制程变更通知单(for Customer)

Process Change Notification for Customer

客户名称 Customer: \_\_\_\_\_ 变更编号 Change Number: \_\_\_\_\_ 1800004

| 变更项目<br>Change Item   | Change raw resin from LCP E6810 to LCP G245                                                                                                                                                                                                                                                                                                                                                                                                                               |                      |                  |

变更前 Before Change(P/N:8010001582/1682)

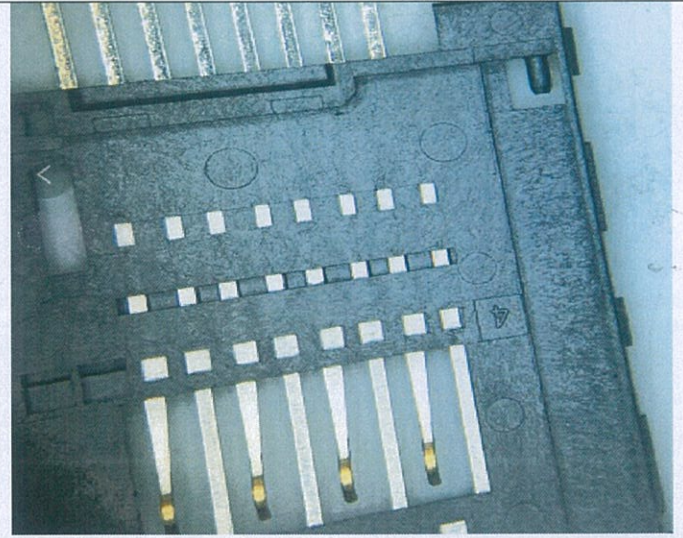
| 变更理由<br>Change Reason | At present, the resin LCPE6810 is used to produce molding parts. Due to the special characteristics of this resin, plastic chips generates during molding process and stick to the mold, burr around the molding parts happens when the chips accumulates to a certain degree. To eliminate the burrs for improving quality and efficiency, new resin LCPG245 is recommended. We apply for this change after getting positive results, please refer to the pictures below |                      |                  |
